# Access Compliance Report

## Public Rights-of-Way

| Intersection ID: 29374                  | Main Street: BUCKVALLEY_DR | Cross Street: PLEASANT_DALE_DR          | Location: SE           |
| ADA ID: C6B724FAB529                    | Ramp Type: PerpDiag        | Initial Pass/Fail: Fail                 | Overall Compliance: No |

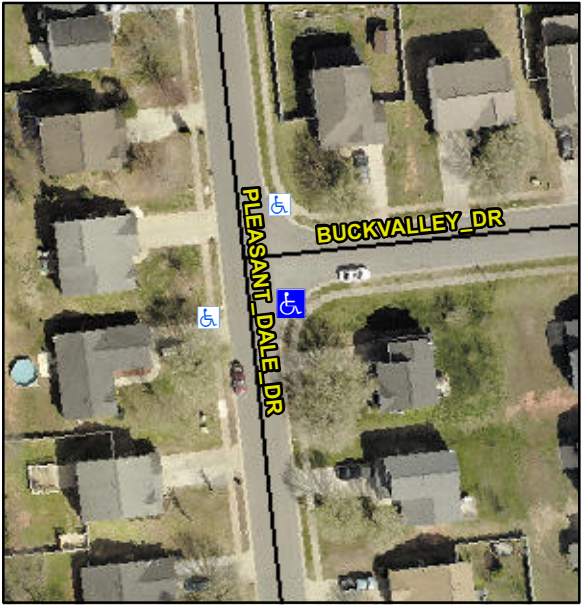
|  |  | Yes | Ramp Width (in)       | 48.0 | No  | Ramp XSlope (%)             | 5.1  |
| <p>Surveyor Notes:</p> <p>N/A</p> <p>PROW/ADA:</p> <p>Not Found, R304.5.3</p>    |  |     | Road Slope (%)        | 2.7  | N/A | Clear Space?                | N/A  |

|  | Remove & Replace Curb Ramp With Two New Directional Ramps or Equivalent. | N/A | Ramp Length (in)      | 47.0 | Yes | Ramp Slope (%)              | 5.2  |
